WATERBURY SANITARY FORCE MAIN

EL PASO COUNTY, CO

UTILITY CONSTRUCTION SET

APRIL 2026

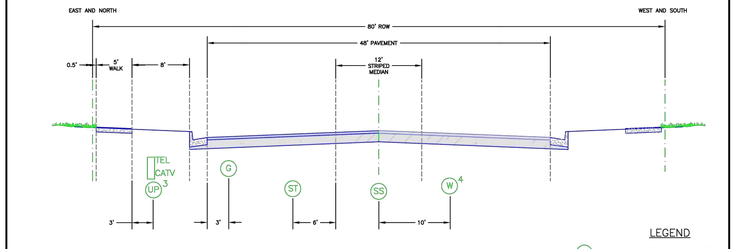
Replace this detail with standard detail SD_4-6

STAPLETON ROW CROSS SECTIONS
1" = 20'

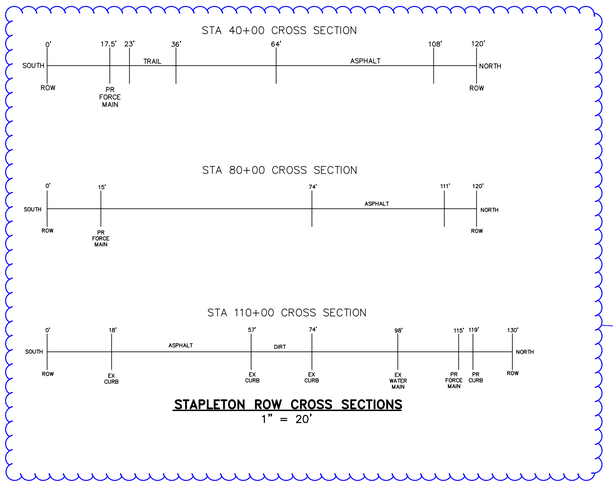
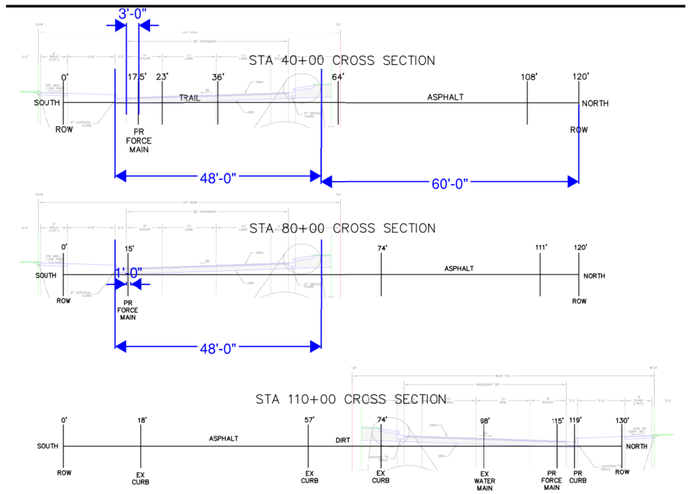
You are NOT showing the cross sections overlaid on your your horizontal lines (please see the example below, this example is not to scale and it is for illustration only), these are lines, please show and label the overlaid cross sections. Please use 4 lanes Principle Arterial Cross sections. Please center the FM on the 6' wide shoulder (3' on each side, see below). Jeff comment

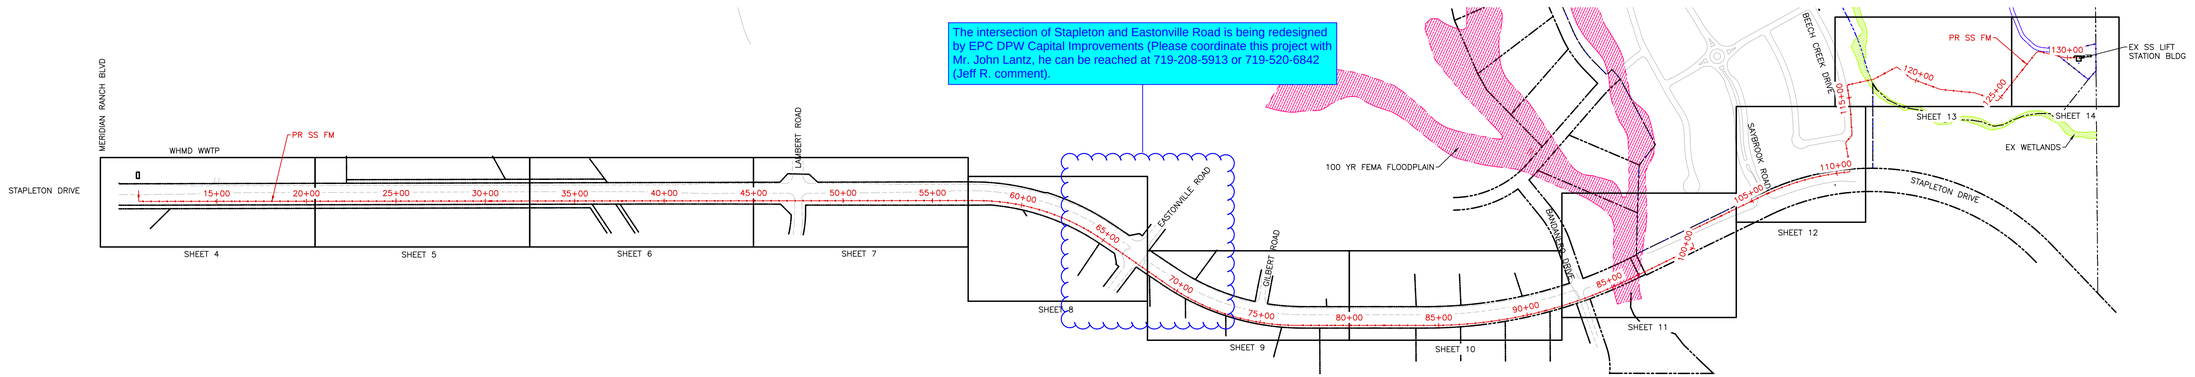
The intersection of Stapleton and Eastonville Road is being redesigned by EPC DPW Capital Improvements (Please coordinate this project with Mr. John Lantz, he can be reached at 719-208-5913 or 719-520-6842 (Jeff R. comment).

UTILITY CONSTRUCTION SET
SANITARY FORCE MAIN PLAN & PROFILE

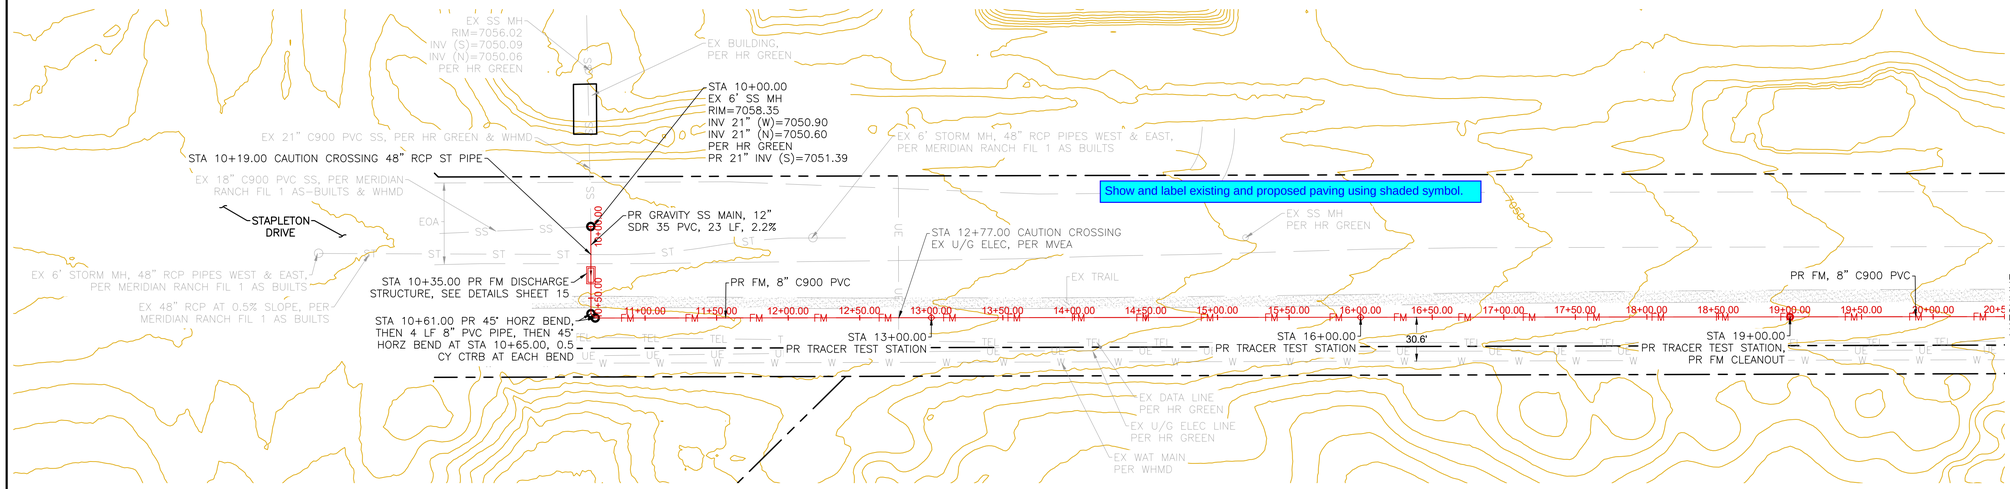
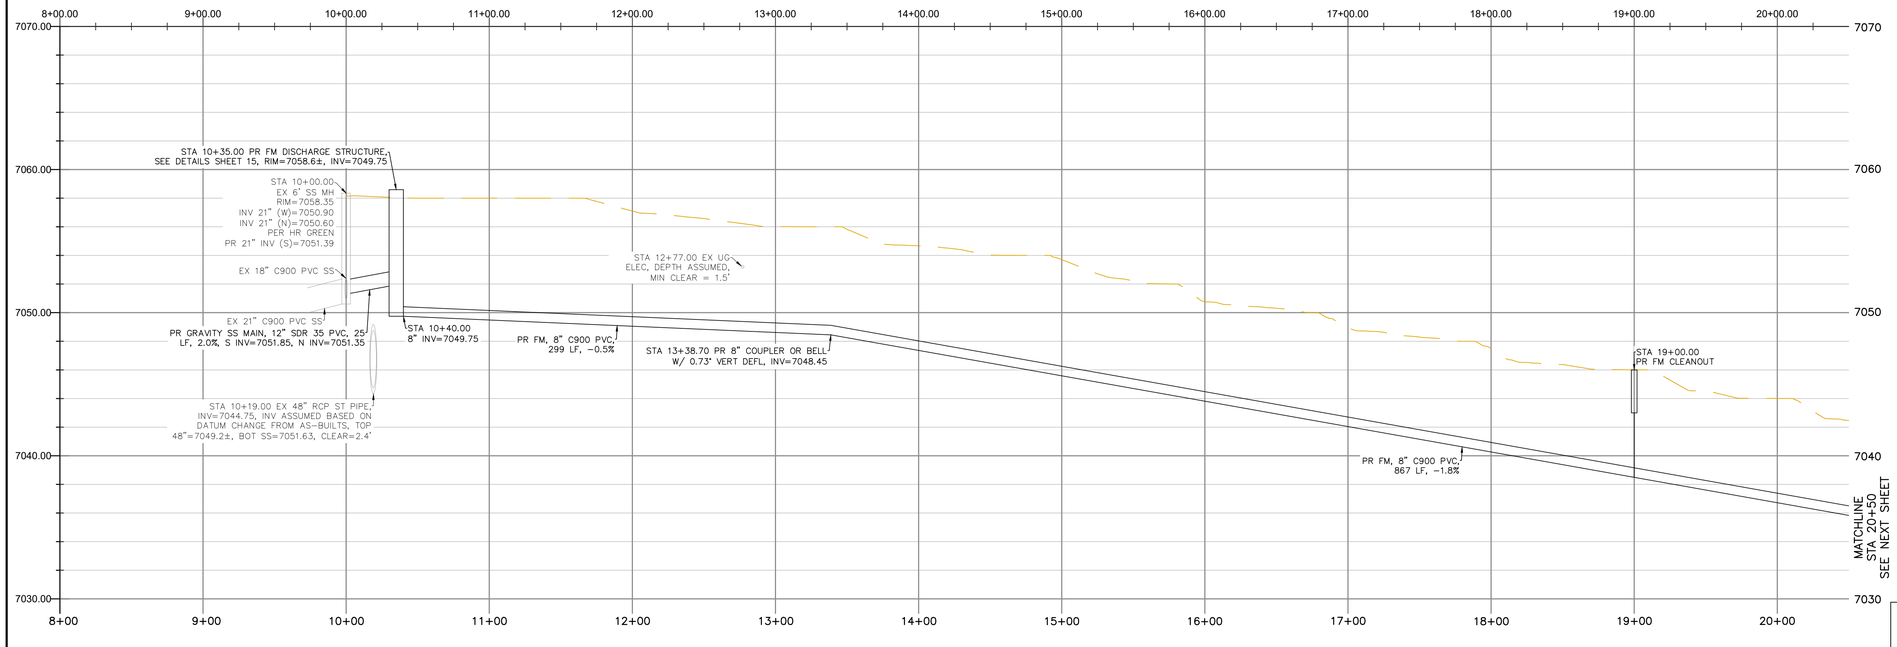
Add the following note "the open cut shall not exceed 250 LF per day, the developer can not open ground if he/she can not back fill it at the end of the same day and make it safe to the public (No open cut to remain open after working hours).".

Show and label existing and proposed paving using shaded symbol.

UTILITY CONSTRUCTION SET
SANITARY FORCE MAIN PLAN & PROFILE

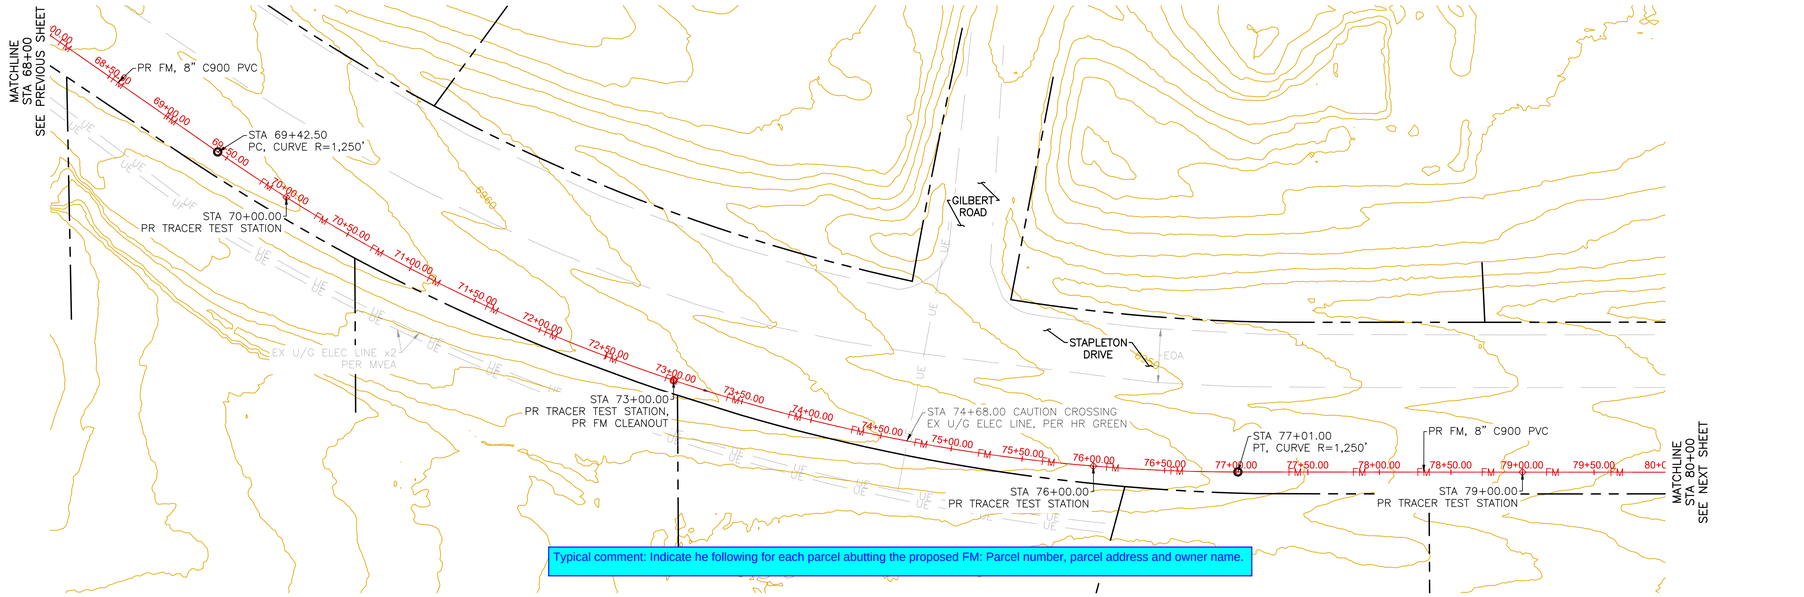
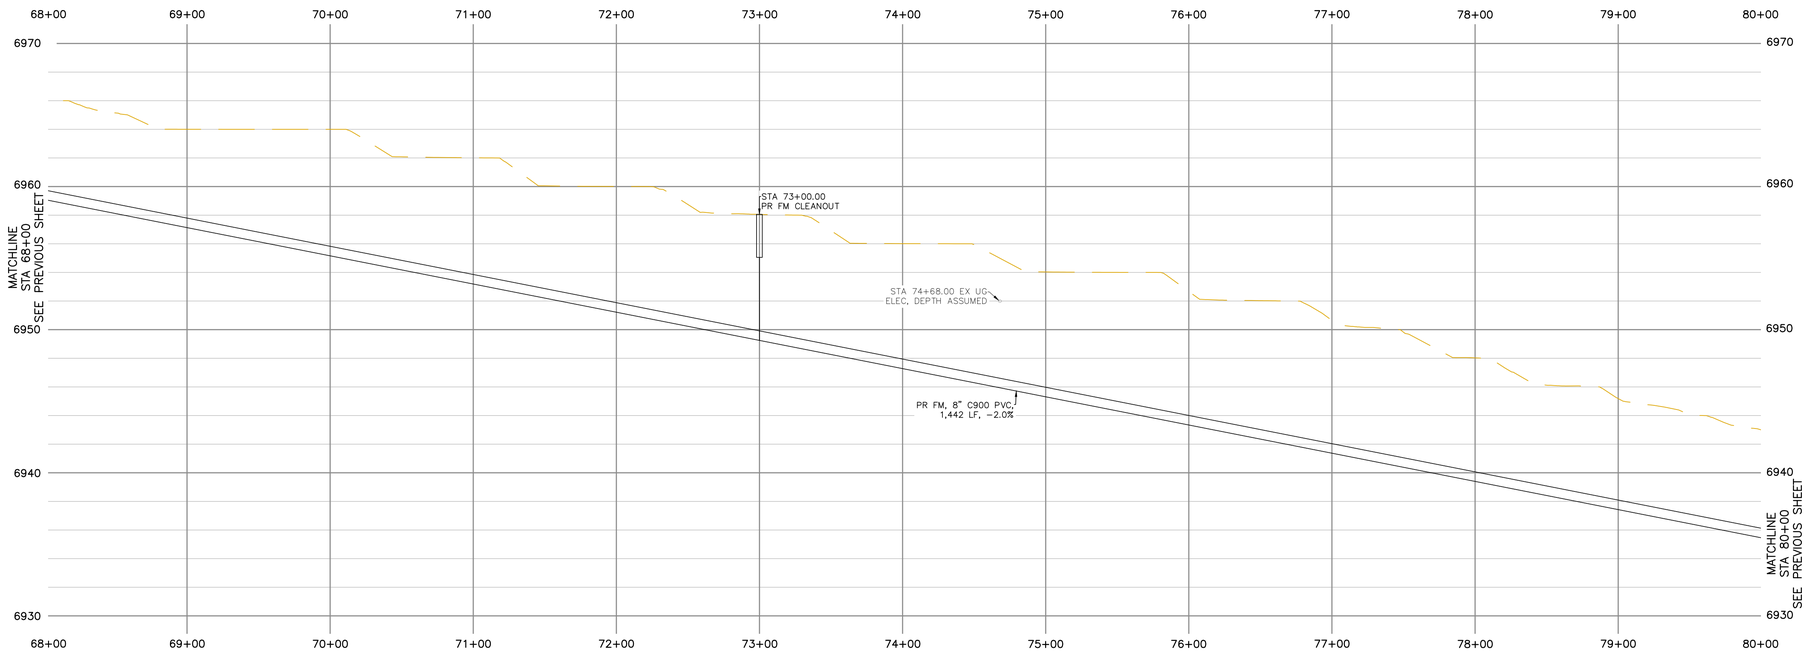
Typical comment: Indicate he following for each parcel abutting the proposed FM: Parcel number, parcel address and owner name.

UTILITY CONSTRUCTION SET
SANITARY FORCE MAIN PLAN & PROFILE

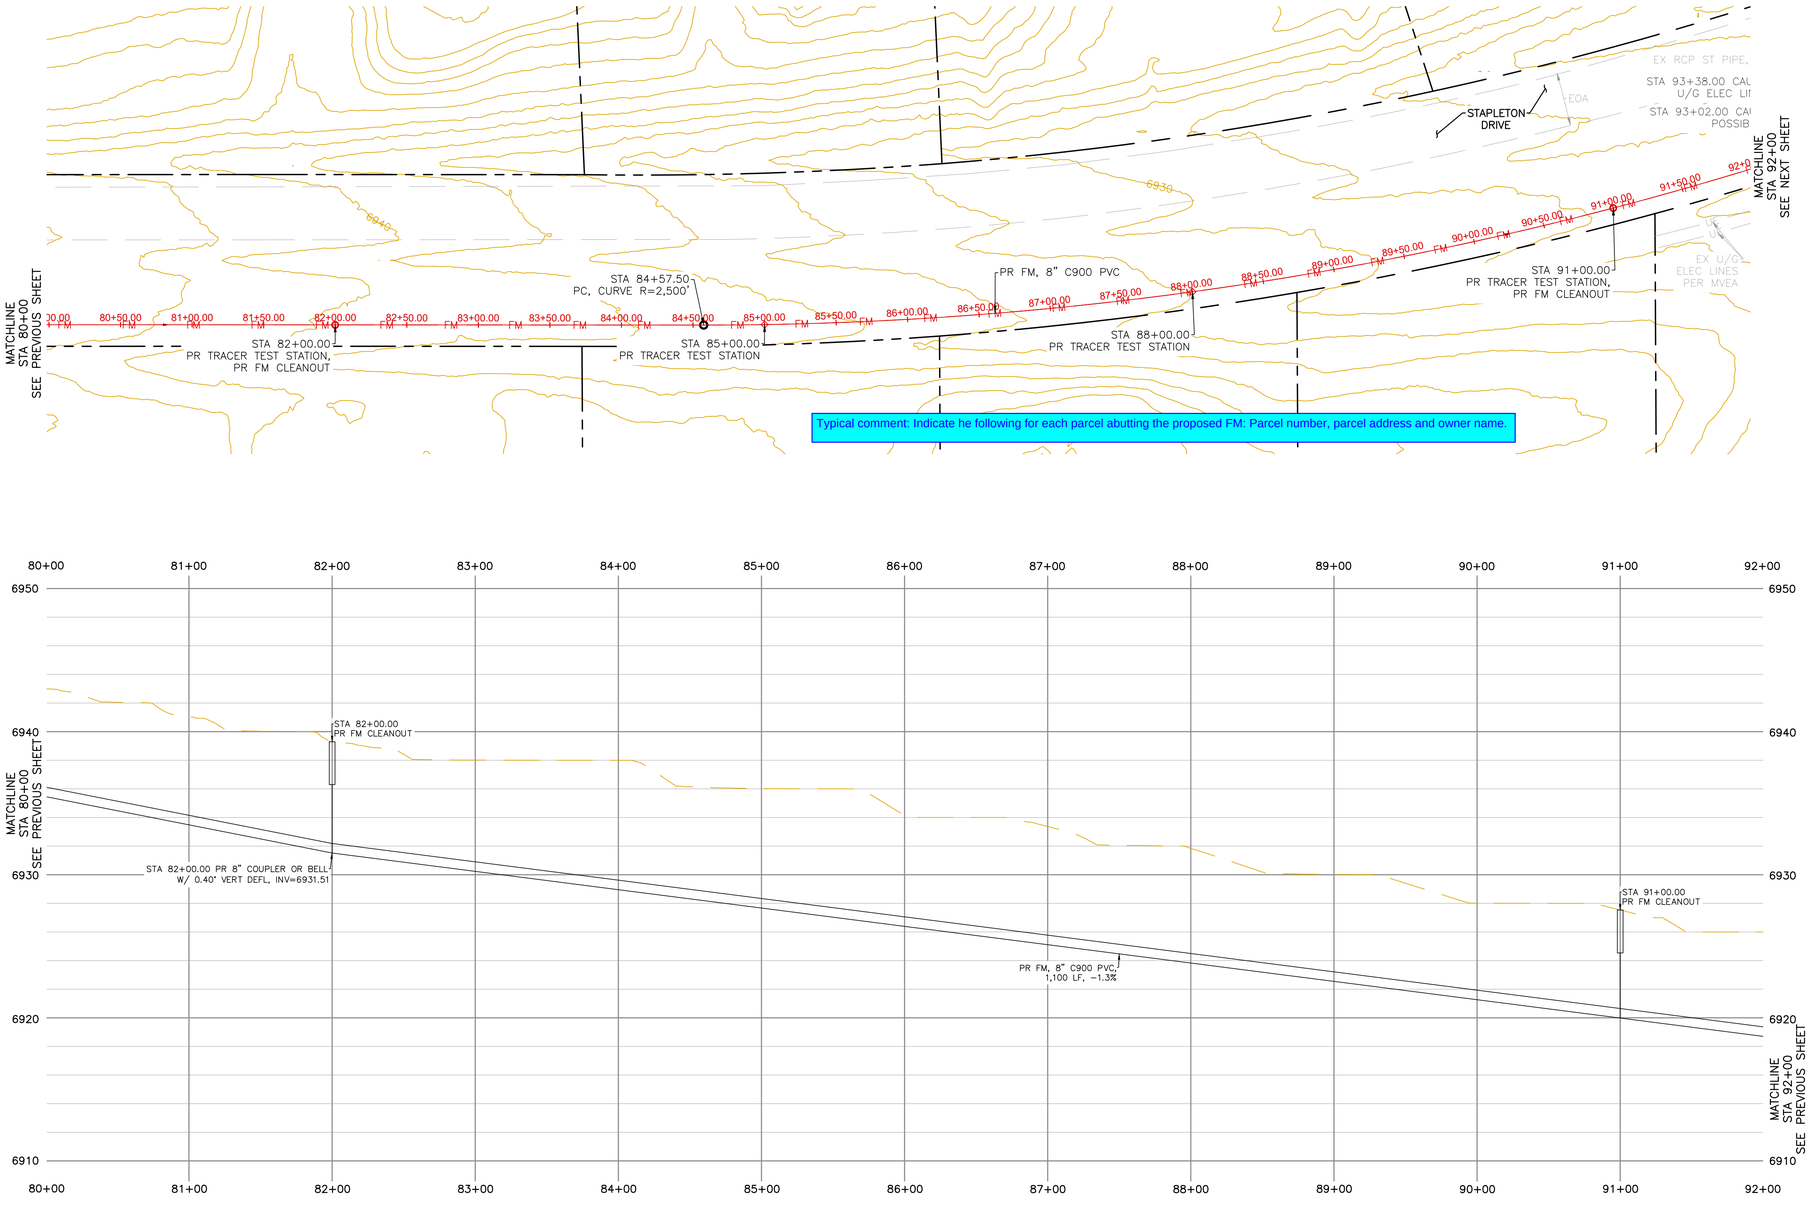
Typical comment: Indicate he following for each parcel abutting the proposed FM: Parcel number, parcel address and owner name.

UTILITY CONSTRUCTION SET
SANITARY FORCE MAIN PLAN & PROFILE

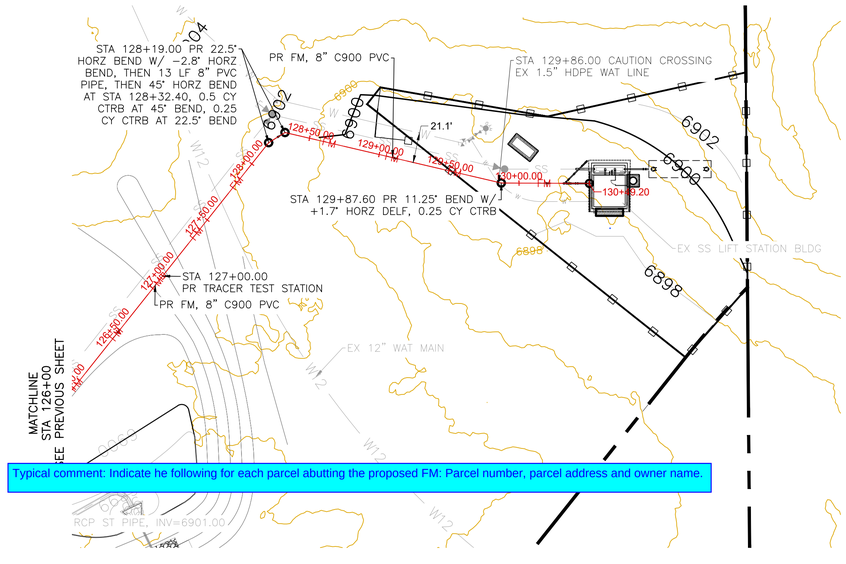
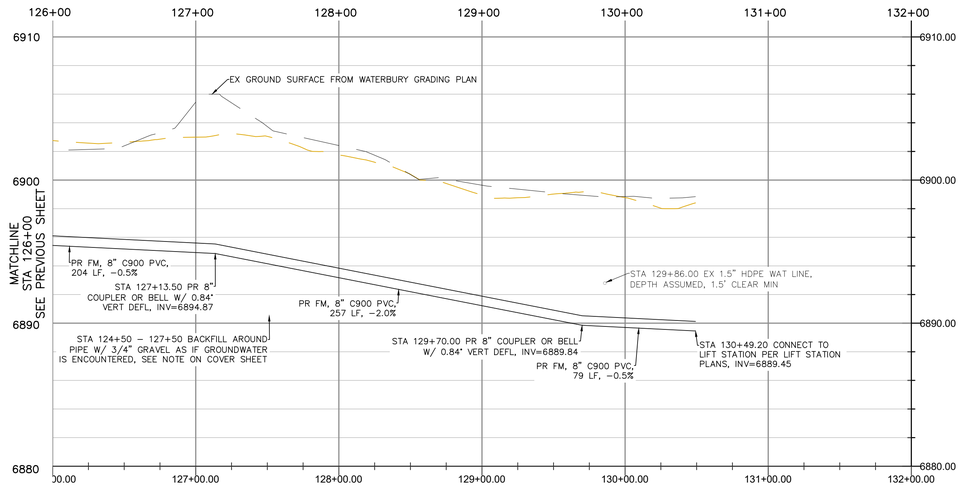
Typical comment: Indicate he following for each parcel abutting the proposed FM: Parcel number, parcel address and owner name.
